STATE OF MAINE
DEPARTMENT OF TRANSPORTATION
16 STATE HOUSE STATION
AUGUSTA, MAINE 04333-0016

December 4, 2018
Subject: Piscataqua River Bridge Wearing
Surface Replacement
State WIN: 019270.00
Location: **Kittery & Portsmouth, N.H.**
Amendment No. 1

ADD the attached SHEET NUMBER 221A OF 230, PROTECTIVE SCREENING DETAILS.

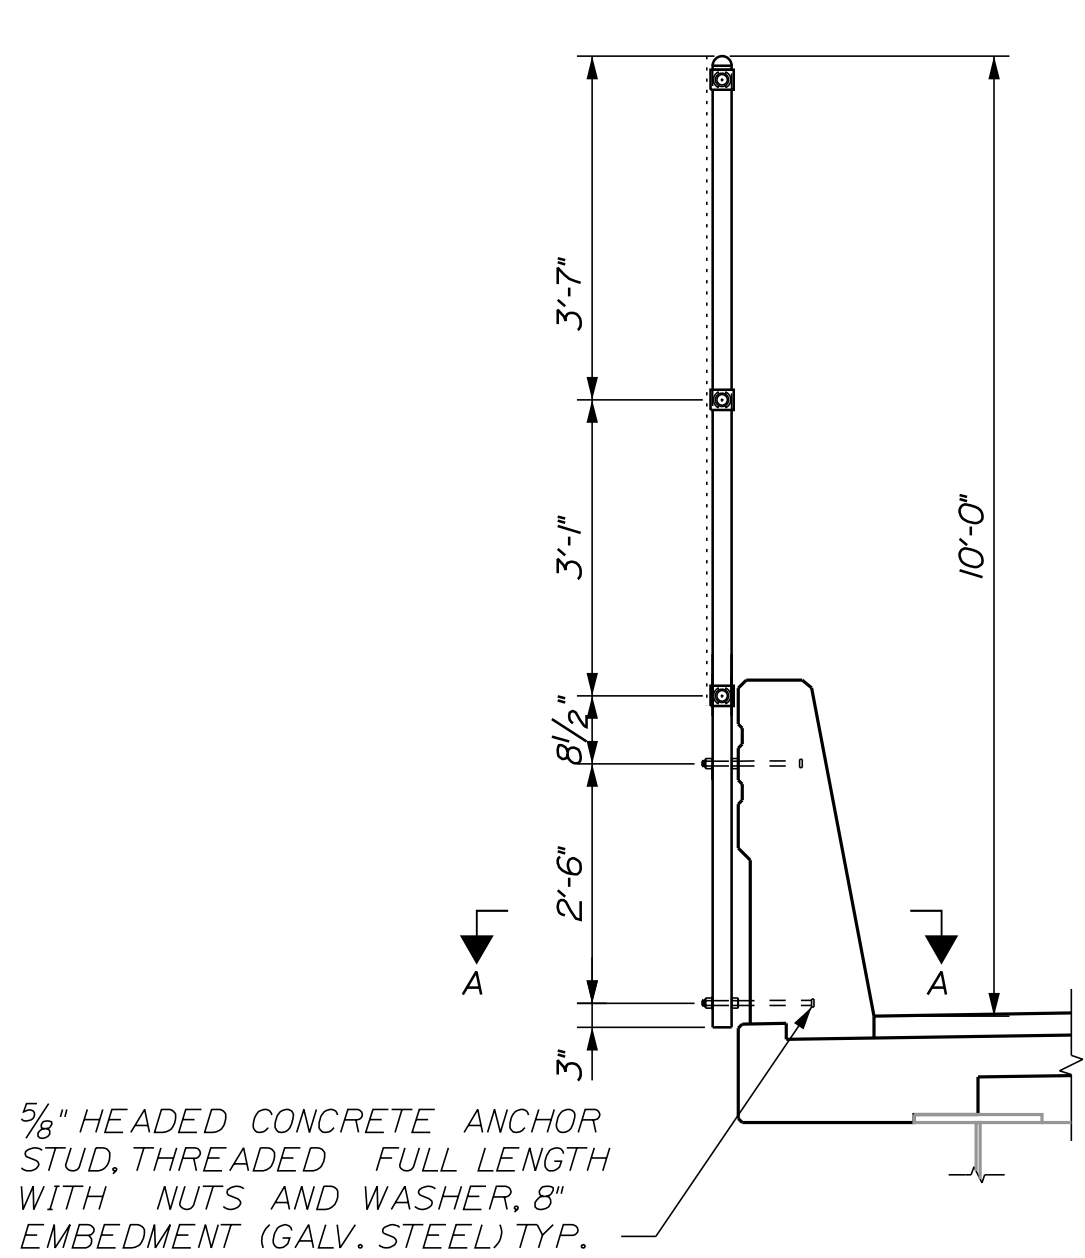
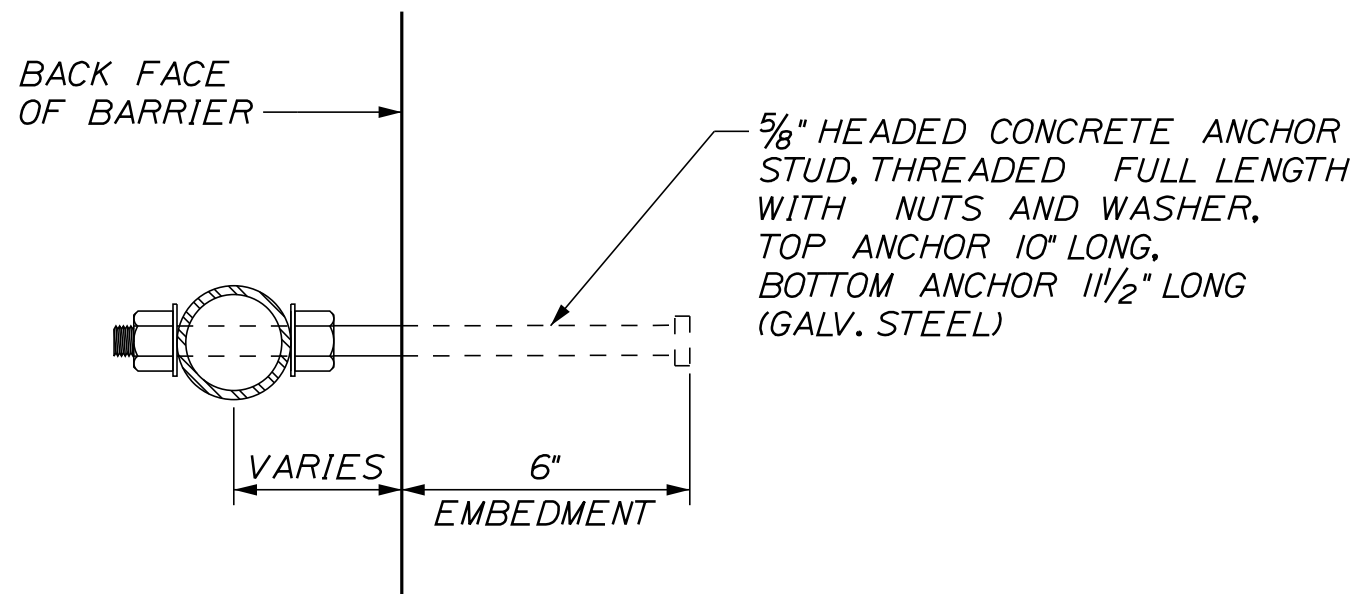
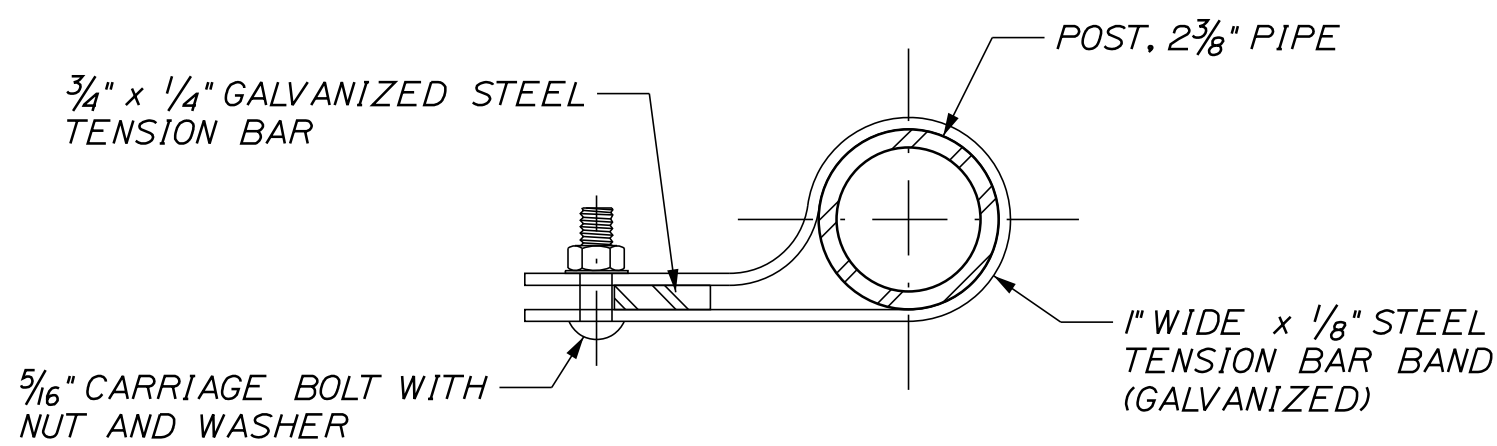
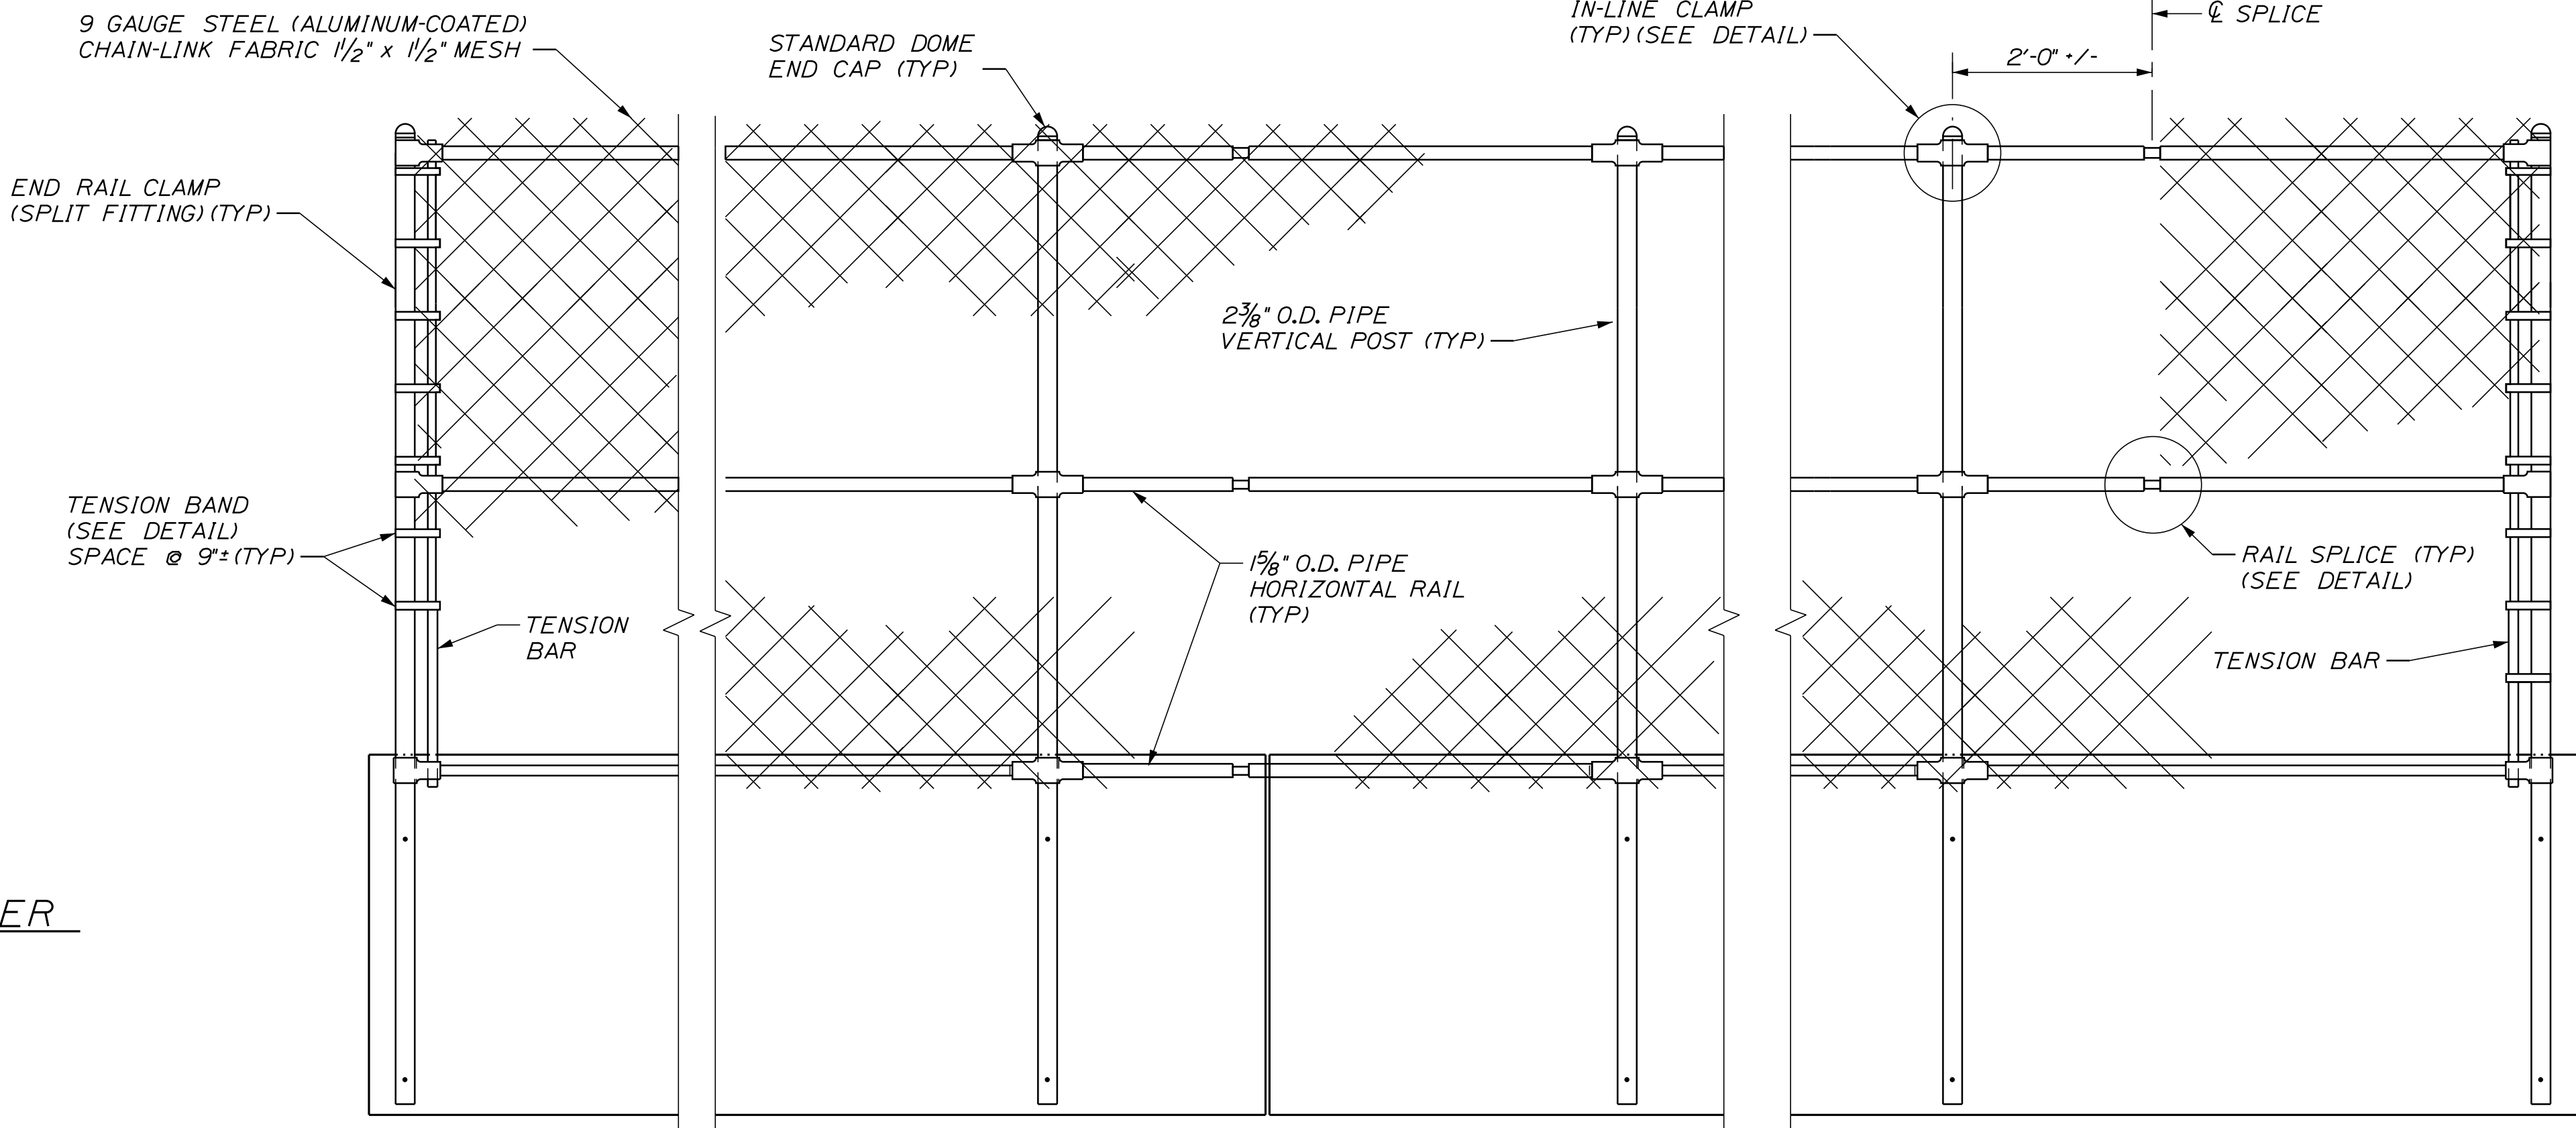
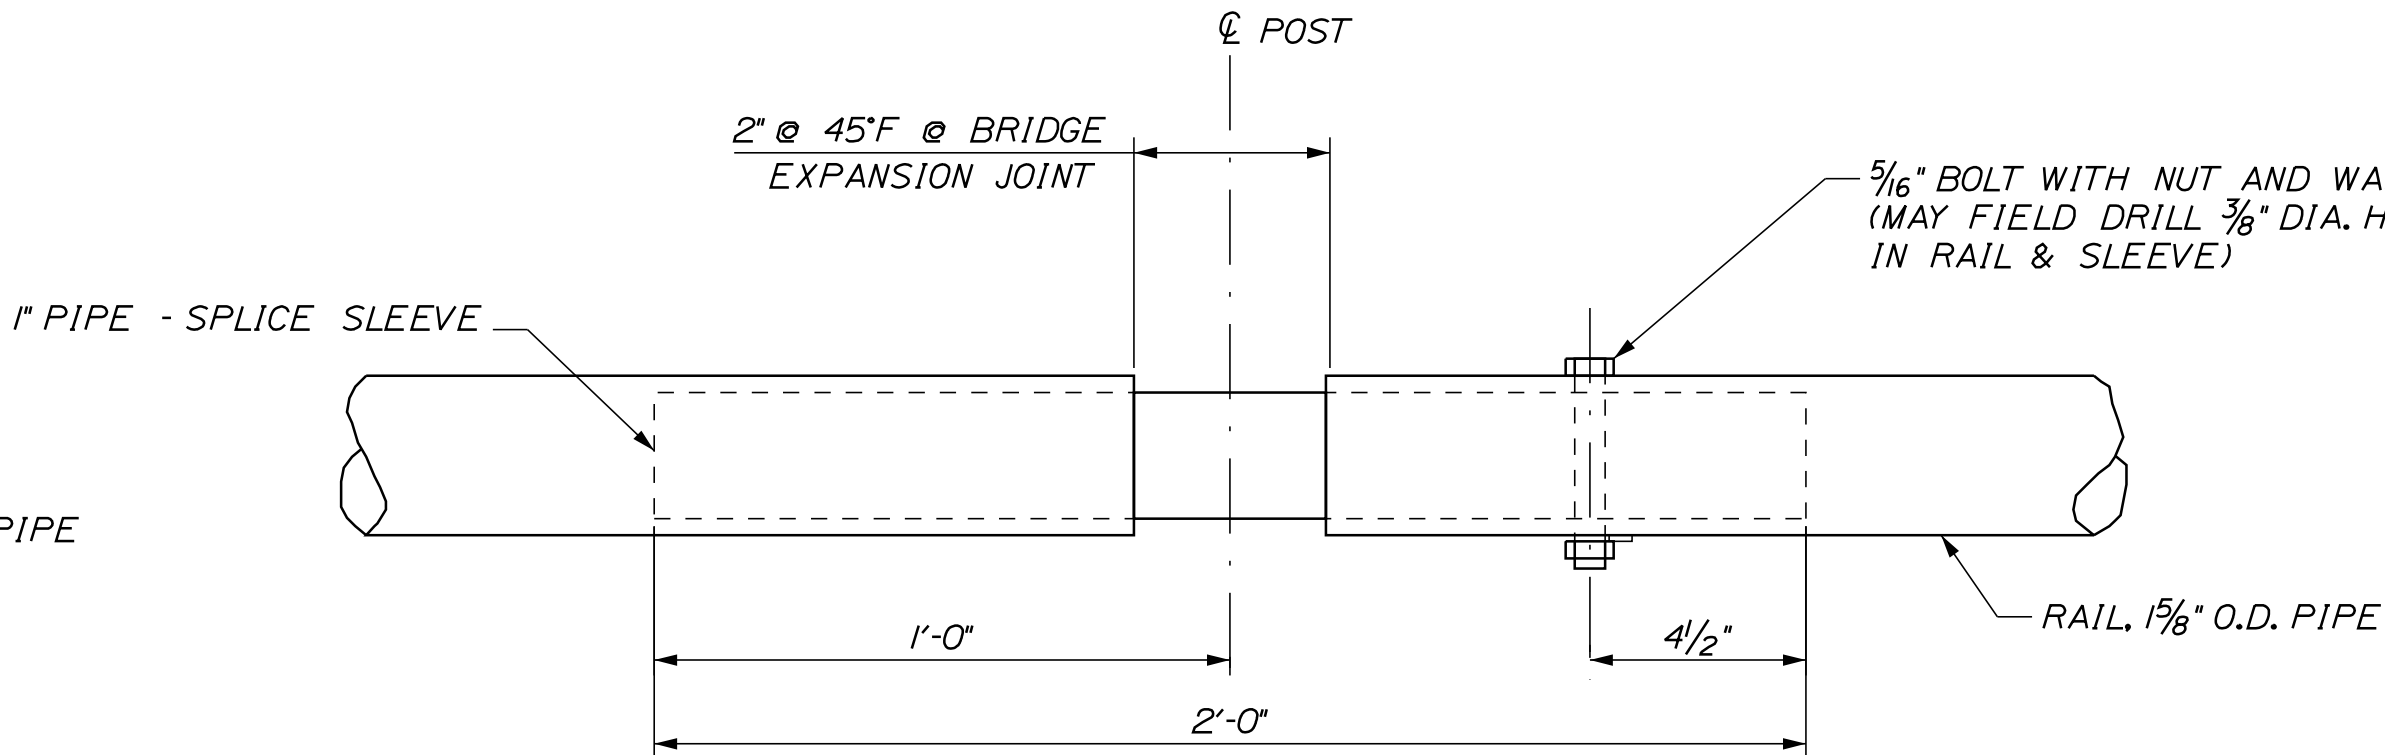
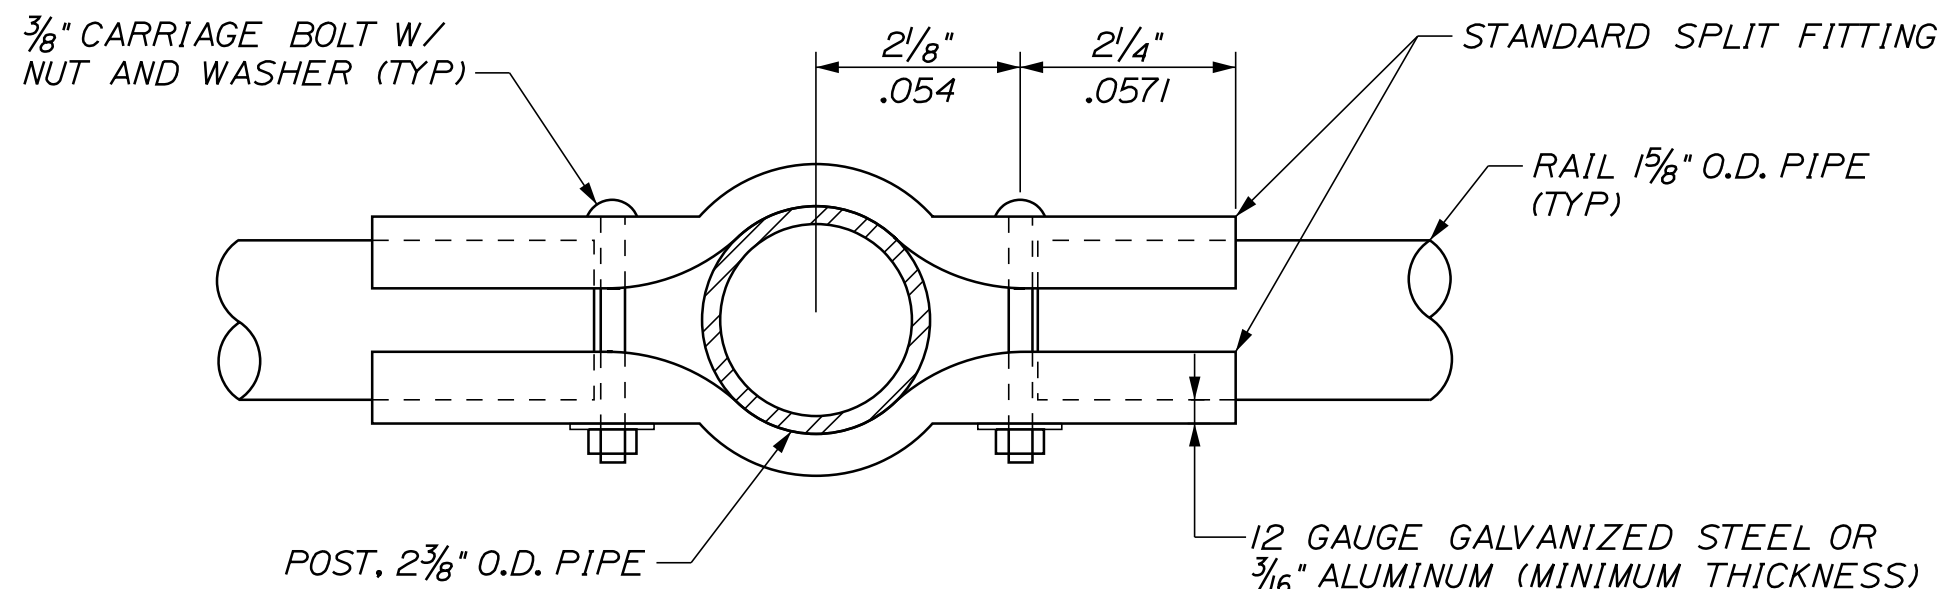
ADD the attached SPECIAL PROVISION – SECTION 607 – FENCES – (Protective Screening), 1 page, dated November 30, 2018.

The work shall include the installation of Protective Screening on the bridge to the limits shown on the plans.

The accepted quantities of Protective Screening shall be paid for at the contract unit price per foot of Protective Screening. Payment shall be full compensation for furnishing and installing all materials as shown on the plans including labor, tools, and incidentals required to complete the installation.
